Title - Sujet New 50 Man Living Units - Ferndale	
Solicitation No. - N° de l'invitation EZ899-131401/A	Amendment No. - N° modif. 003
Client Reference No. - N° de référence du client	Date 2012-10-30
GETS Reference No. - N° de référence de SEAG PW-\$PWY-005-6794	
File No. - N° de dossier PWY-2-35164 (005)	CCC No./N° CCC - FMS No./N° VME
Solicitation Closes - L'invitation prend fin at - à 02:00 PM on - le 2012-11-09	Time Zone Fuseau horaire Pacific Daylight Saving Time PDT
F.O.B. - F.A.B. Plant-Usine: <input type="checkbox"/> Destination: <input checked="" type="checkbox"/> Other-Autre: <input type="checkbox"/>	
Address Enquiries to: - Adresser toutes questions à: Pillay, Sal (PWY)	Buyer Id - Id de l'acheteur pwy005
Telephone No. - N° de téléphone (604) 775-9386 ()	FAX No. - N° de FAX (604) 775-6633
Destination - of Goods, Services, and Construction: Destination - des biens, services et construction: CSC - Ferndale Institution - Mission, BC

Refer to the attached Addendum No. 2 issued 30th October 2012.

The following changes in the tender documents are effective immediately. This addendum will form part of the contract documents.

Proj. No. R04494.001	Scale: N.T.S.	Date: 12Oct29	Designed: K.B.	Drawing No.: ESK-E001-01
-------------------------	------------------	------------------	-------------------	-----------------------------

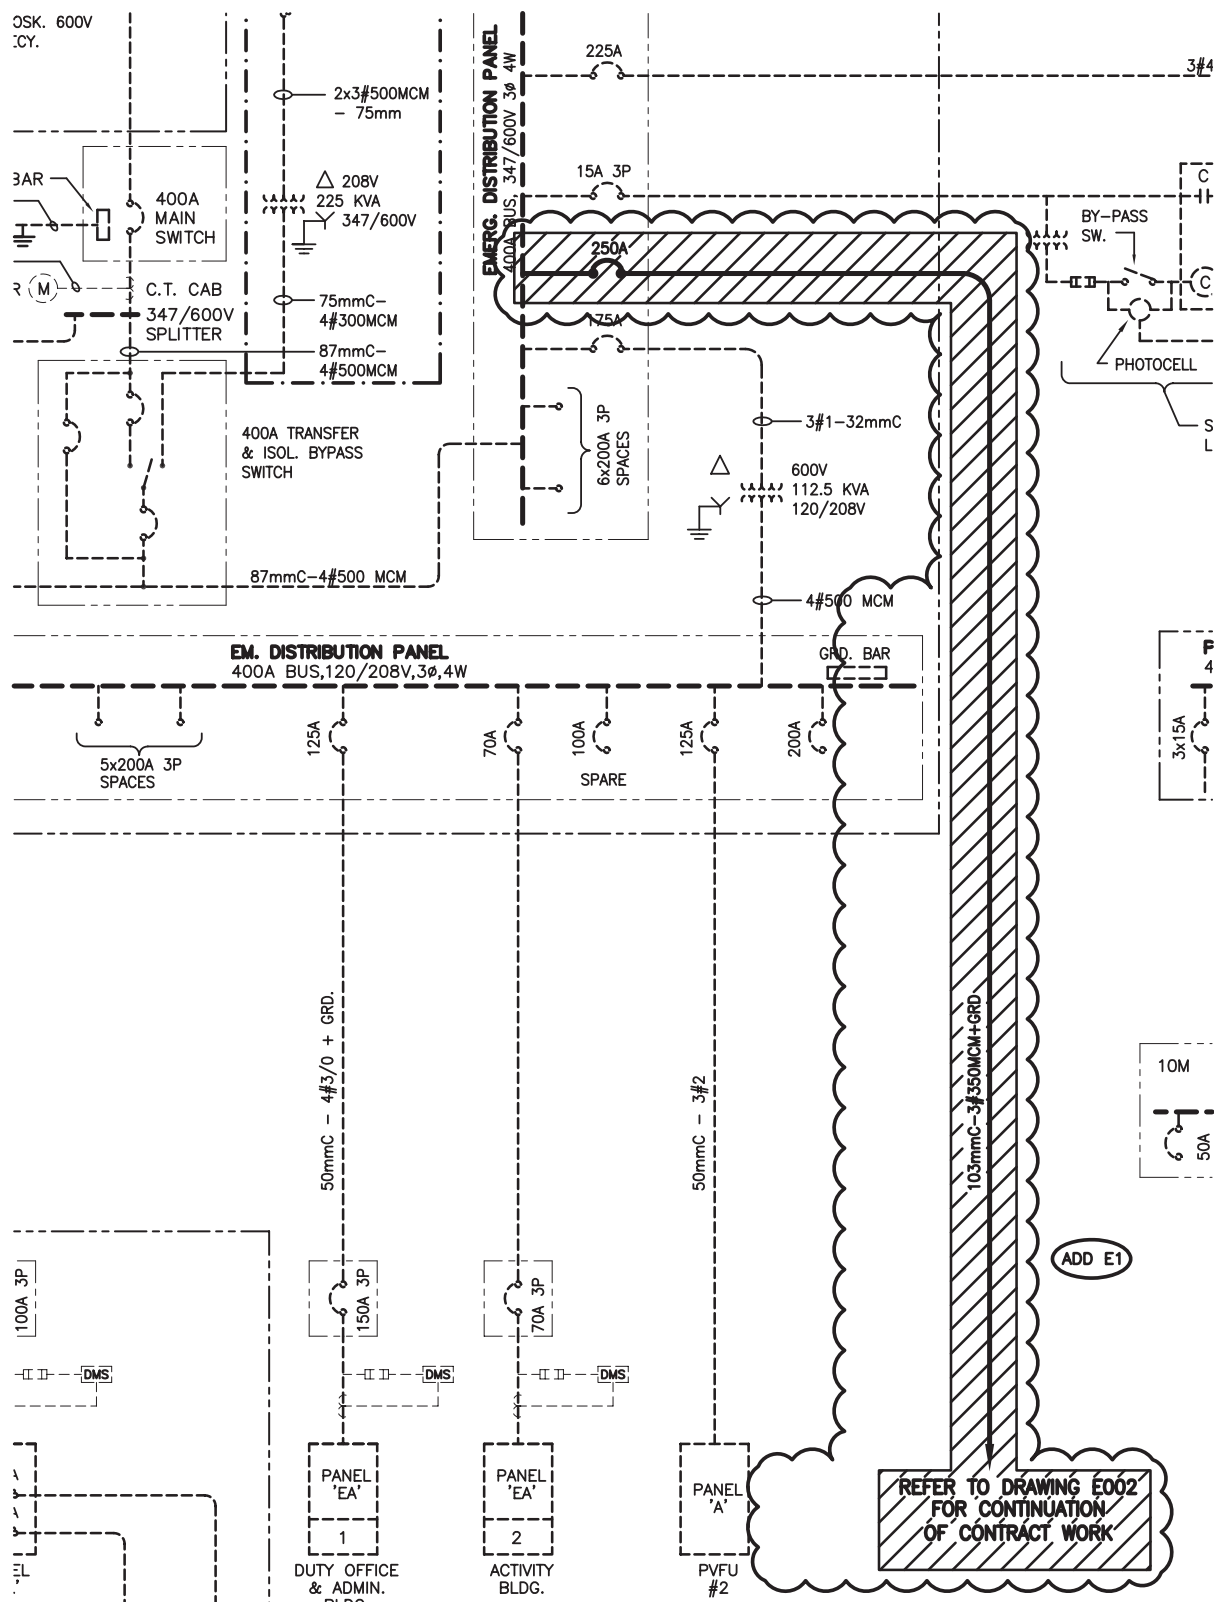
- (46) **Clarification:** Fifty Man Living Unit electrical service shall be connected to 'EMERG. DISTRIBUTION PANEL' (347/600V) and not 'EM. DISTRIBUTION PANEL' (120/208V) as shown. Refer to ESK-E001-01 for details
-

Proj. No. R04494.001	Scale: N.T.S.	Date: 12Oct29	Designed: K.B.	Drawing No.: ESK-E100-01
-------------------------	------------------	------------------	-------------------	-----------------------------

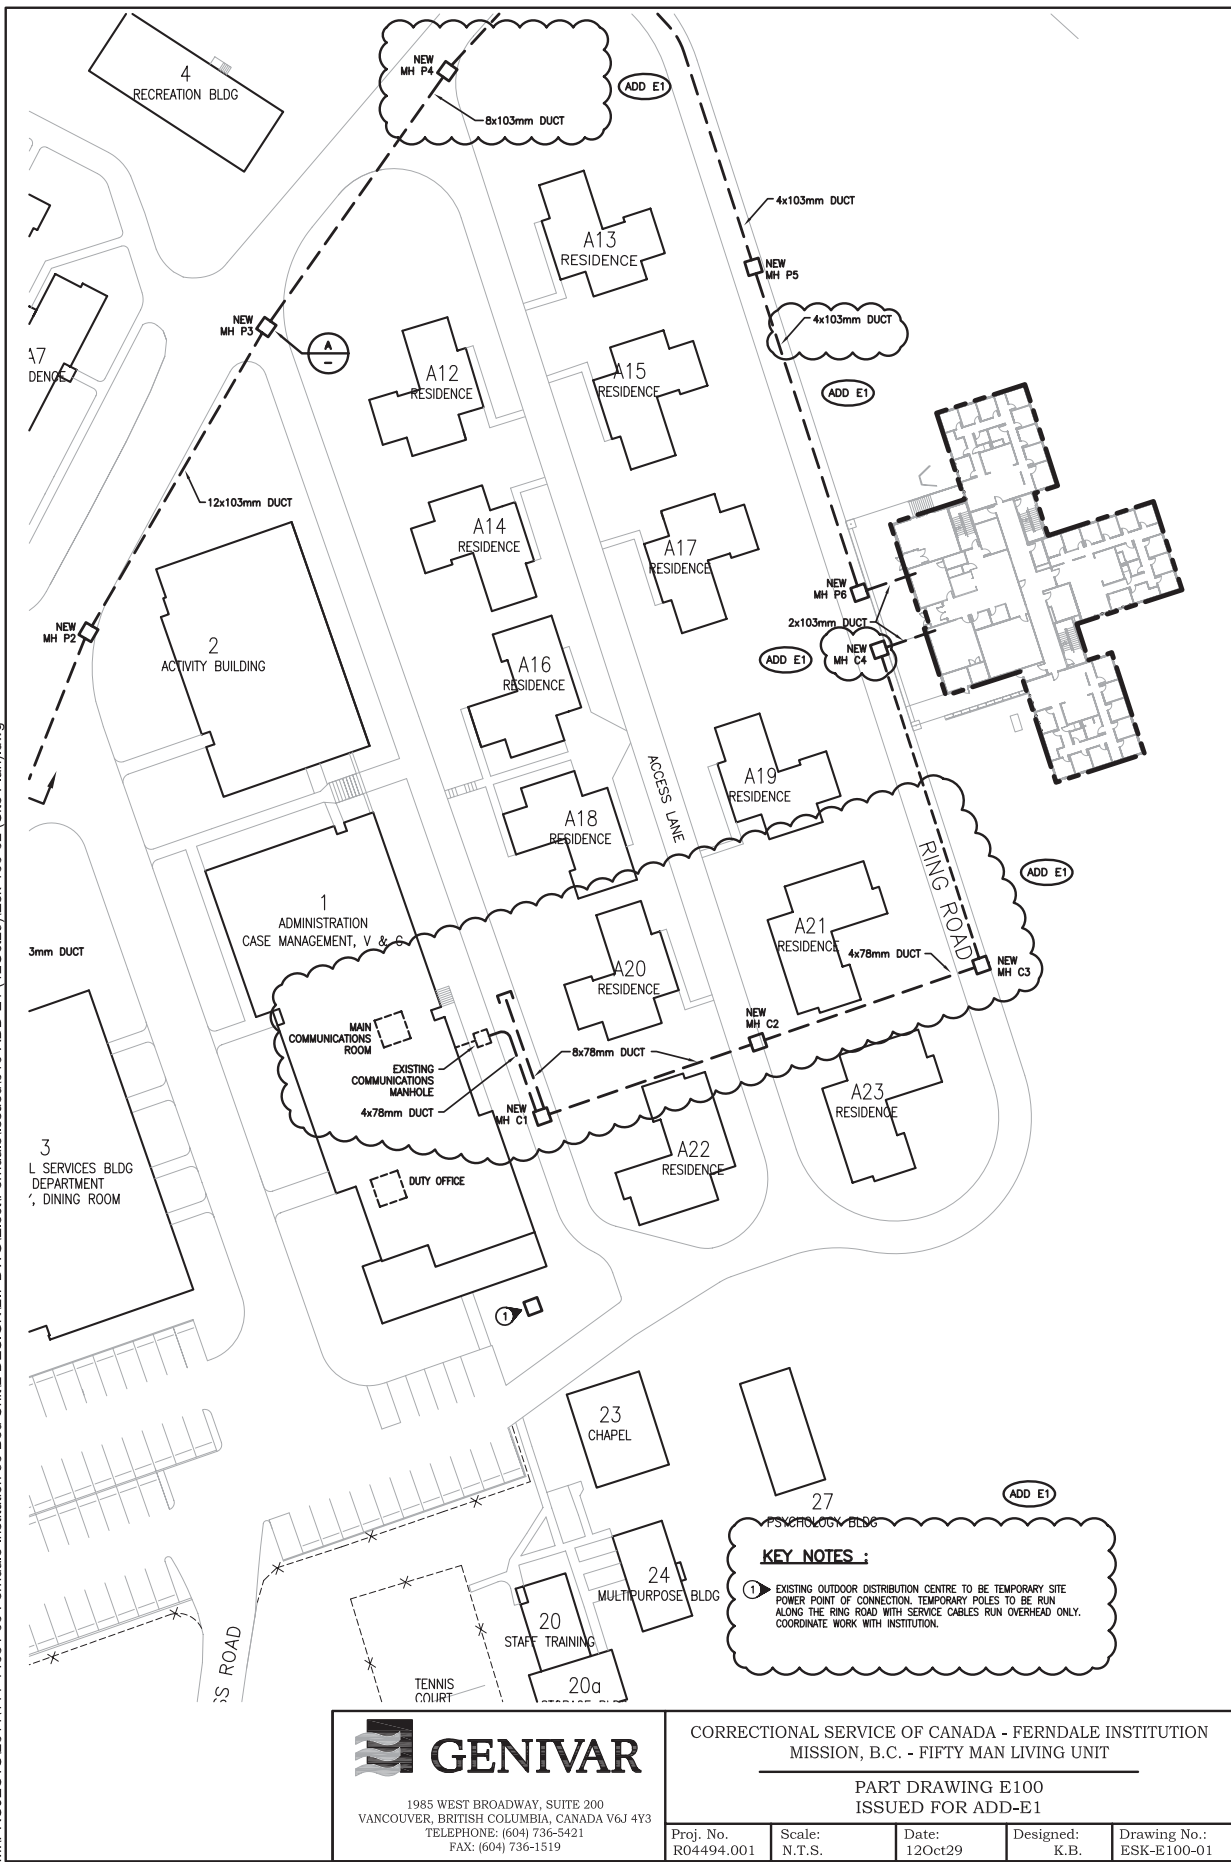
- (50) **Add:** One communication manhole east of 'Residence A21'. Refer to ESK-E100-01 for manhole location and revised manhole descriptions.
- (51) **Revise:** Refer to ESK-E100-01 for revised manhole layouts and duct routing.
- (52) **Revise:** 'Detail B, Note 1' to read, "Unless indicated otherwise, all outdoor duct runs shall be concrete encased and installed at 600mm below grade."
